Our ref: Minarah College (SSD-30759158)

Subject: Response to Submissions – Department’s Key Issues

Preliminary Peer review – Transport and Accessibility Impact Assessment

Figure 1: Trip distribution assumptions

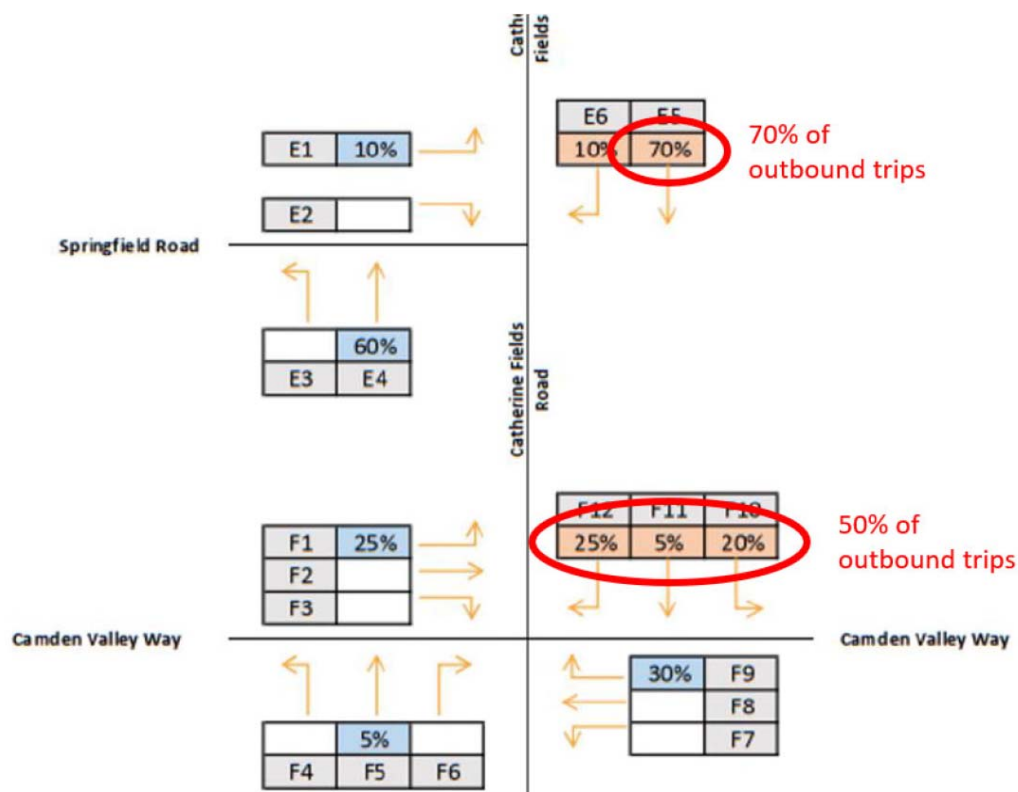
The trip distribution assumptions noted in Section 6.2.1 of the TAIA indicate that 70% of outbound trips travel south along Catherine Fields Road past Springfield Road, however only 50% of trips are distributed at the Catherine Fields Road / Camden Valley Way intersection (see Figure 1 below).

There is a missing 20% of outbound trips that has potentially not been considered in the analysis. Further, the inbound trip distribution does not align with the outbound distribution. Updating the trip distribution assumptions along Catherine Fields Road may have further implications for operational capacity and safety.

Clarification as to the trip distribution assumptions should be provided and analysis (including traffic modelling) updated as required.

Figure 3: Likely travel route from the site to Bringelly Road

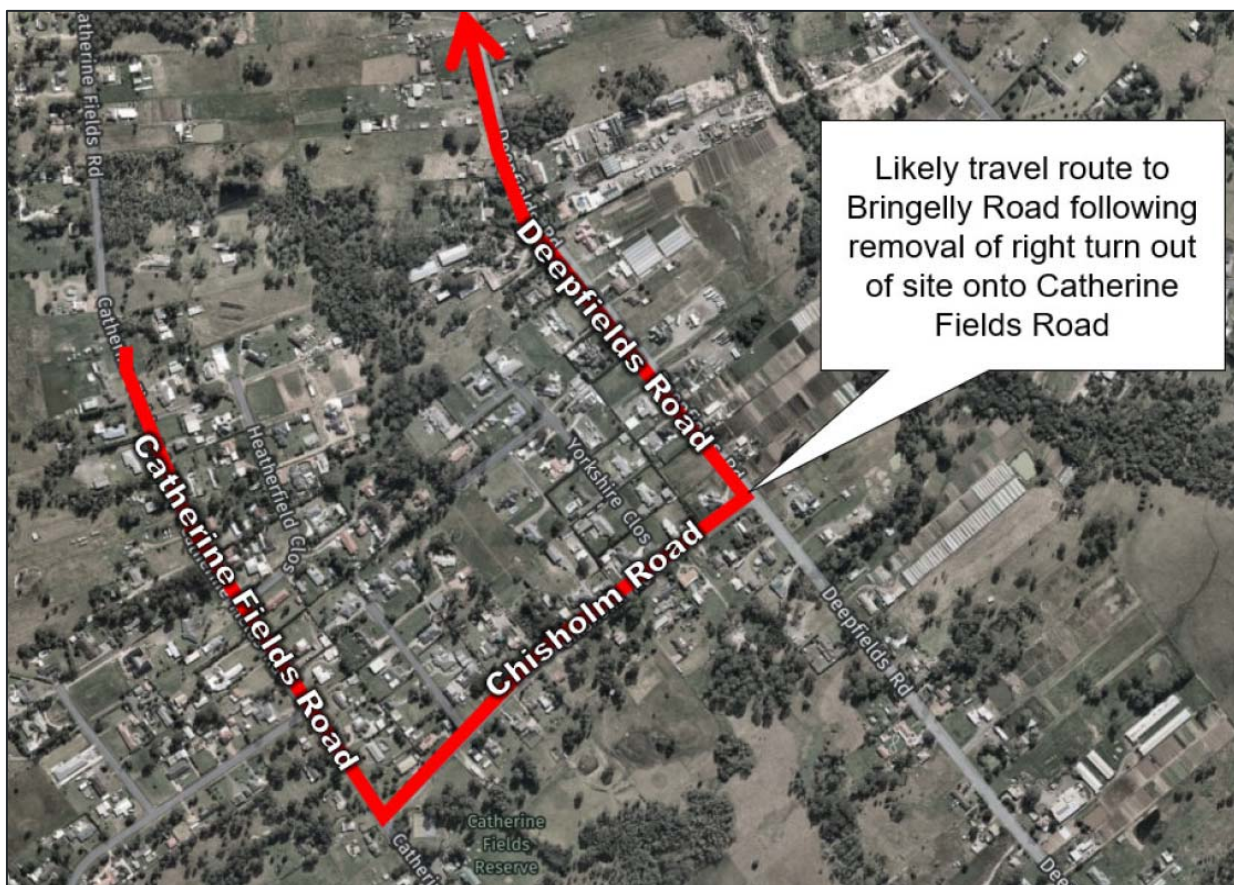
To mitigate traffic impacts following Stage 5 of the proposal it is proposed to direct all vehicles leaving the site to turn left onto Catherine Fields Road. This will require drivers wanting to travel back towards Bringelly Road to travel along Chisholm Road and Deepfields Road (see **Figure 3** below). No assessment of the performance of Chisholm Road, including its intersections with Catherine Fields Road and Deepfields Road, has been considered in the analysis.

Further detail is required (including traffic modelling) of the performance of Chisholm Road including its intersections with Catherine Fields Road and Deepfields Road at Stage 5 of the proposed development.
